**LEVY NUCLEAR PLANT, UNITS 1 AND 2
DOCKET NOS. 52-029 AND 52-030
RESPONSE TO REQUEST FOR ADDITIONAL INFORMATION LETTER NO. 085 RELATED TO
SEISMIC SYSTEM ANALYSIS**

**Levy Nuclear Plant Units 1 and 2
Response to NRC Request for Additional Information Letter No. 085 Related to
SRP Section 3.7.2 for the Combined License Application, dated March 16, 2010**

NRC Letter No.: LNP-RAI-LTR-085

NRC RAI #: 03.07.02-01

CONCEPTUAL DESIGN DETAIL TO
 ACCOMMODATE NUCLEAR ISLAND AND
 ADJACENT BUILDING RELATIVE
 DISPLACEMENTS
 FIGURE RAI 03.07.02-01-1 Rev 0

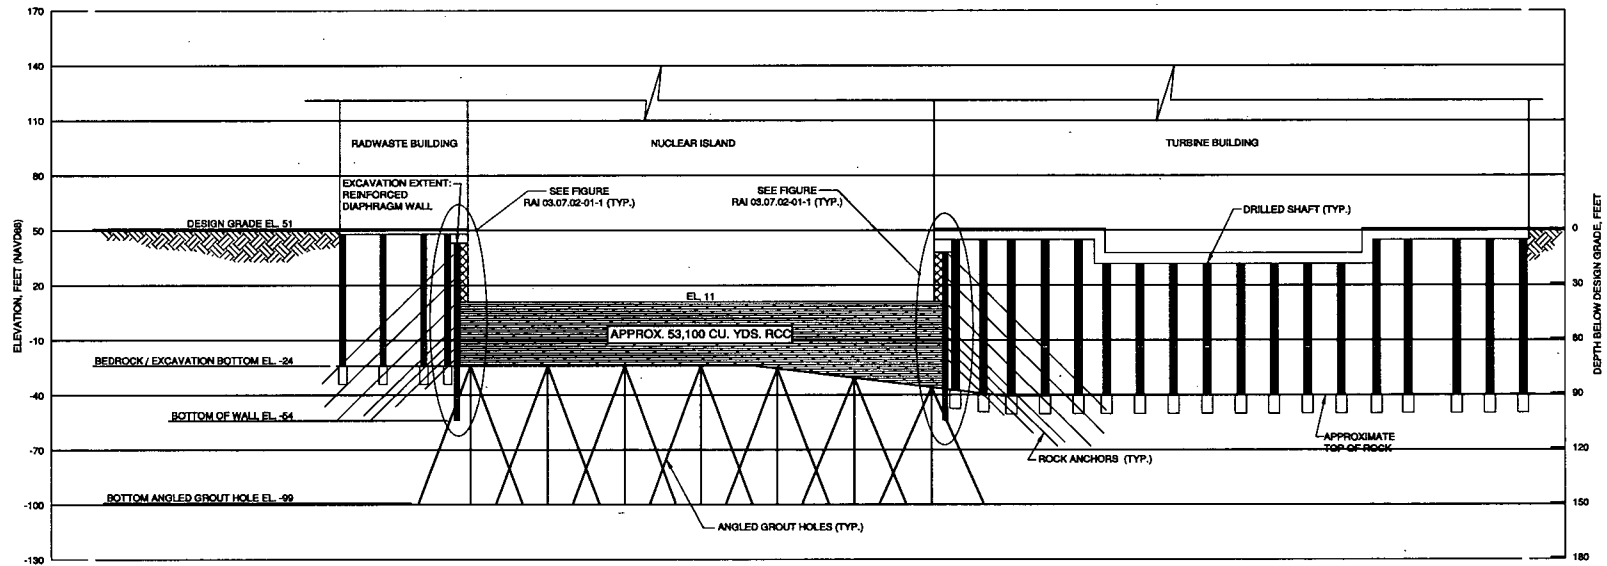
LNP FSAR Figure 2.5.4.5-201B indicates that a cementitious fill will be placed adjacent to the NI structures and fill the region between the NI structures and the diaphragm wall. FSAR Section 3.7.2.8 indicates that structure to structure interaction will not occur since the gap between the NI and adjacent structures is larger than the expected movement based on the maximum displacement seen in the GMRS. The construction details provided in Figure 2.5.4.5-201B indicate that the adjacent buildings rest on the diaphragm wall. Since there is no gap between the diaphragm wall and NI, it appears that the construction detail does not provide a gap as required by the AP1000 DCD.

1. Please provide the basis, including details of construction (diaphragm wall, cementitious fill, location of adjacent structures, etc.), for neglecting potential coupling between the NI and the adjacent structures. If a gap is to be provided, please provide the construction detail of this joint that demonstrates that a gap is in fact assured over the life span of the facility.
2. Please provide the basis for the use of the GMRS associated displacement in lieu of that associated with the performance goal level UHRS.

Figure RAI 03.07.02-01-1 shows the conceptual design detail for the interface between the Nuclear Island (NI) and the drilled shaft supported foundation mats of the adjacent Turbine Building, Annex Building, and the Radwaste Building. This design detail provides the 2 inch gap between the adjacent buildings' foundation mat and the NI consistent with DCD Subsection 3.8.5.1. In addition, the top of the diaphragm wall and controlled low strength material fill between the diaphragm wall and the NI wall is at least 1.5 m (5 ft.) below the bottom of the adjacent buildings' foundation mat. Engineered fill is used from the top of the controlled low strength material fill to the bottom of the adjacent buildings' foundation mat. This interface is designed to avoid hard contact between the NI and the adjacent building foundations resulting from the relative displacements during the seismic event. LNP will implement the AP1000 standard plant design provisions to ensure that the 2-inch gap between the adjacent building foundations and the NI is assured over the life span of the facility.

"For the portion of the diaphragm wall under the Turbine Building, Annex Building, and the Radwaste Building foundation mat, the top of the diaphragm wall will be at least 1.5 m (5 ft.) below the bottom of the respective buildings' foundation mat as shown in Figure RAI 03.07.02-01-1."

Peak foundation elevation displacement resulting from a Performance Based Surface Response Spectra (PBSRS) is conservatively computed to be less than 2.5 cm (1 in.). Figure RAI 03.07.02-01-1 shows the conceptual design detail for the interface between the Nuclear Island (NI) and the drilled shaft supported foundation mat of the Radwaste Building. This design detail provides the 2 inch gap between the Radwaste Building foundation and the NI consistent with DCD Subsection 3.8.5.1. The top of the diaphragm wall and controlled low strength material fill between the diaphragm wall and the NI wall is at least 1.5 m (5 ft.) below the bottom of the Radwaste Building foundation mat as stated in Subsection 2.5.4.5.1. Engineered fill is used from the top of the controlled low strength material fill to the bottom of the Radwaste Building foundation as stated in Subsection 2.5.4.5.4. This interface is designed to avoid hard contact between the NI and the Radwaste Building foundation resulting from the relative displacements during the seismic event. Thus, no seismic interaction between the Radwaste Building and the NI is expected."

Peak foundation elevation displacement resulting from a Performance Based Surface Response Spectra (PBSRS) is conservatively computed to be less than 2.5 cm (1 in.). Figure RAI 03.07.02-01-1 shows the conceptual design detail for the interface between the Nuclear Island (NI) and the drilled shaft supported foundation mat of the Turbine Building. This design detail provides the 2 inch gap between the Turbine Building foundation and the NI consistent with DCD Subsection 3.8.5.1. The top of the diaphragm wall and controlled low strength material fill between the diaphragm wall and the NI wall is at least 1.5 m (5 ft.) below the bottom of the Turbine Building foundation mat as stated in Subsection 2.5.4.5.1. Engineered fill is used from the top of the controlled low strength material fill to the bottom of the Turbine Building foundation as stated in Subsection 2.5.4.5.4. This interface is designed to avoid hard contact between the NI and the Turbine Building foundation resulting from the relative displacements during the seismic event. Thus, no seismic interaction between the Turbine Building and the NI is expected."
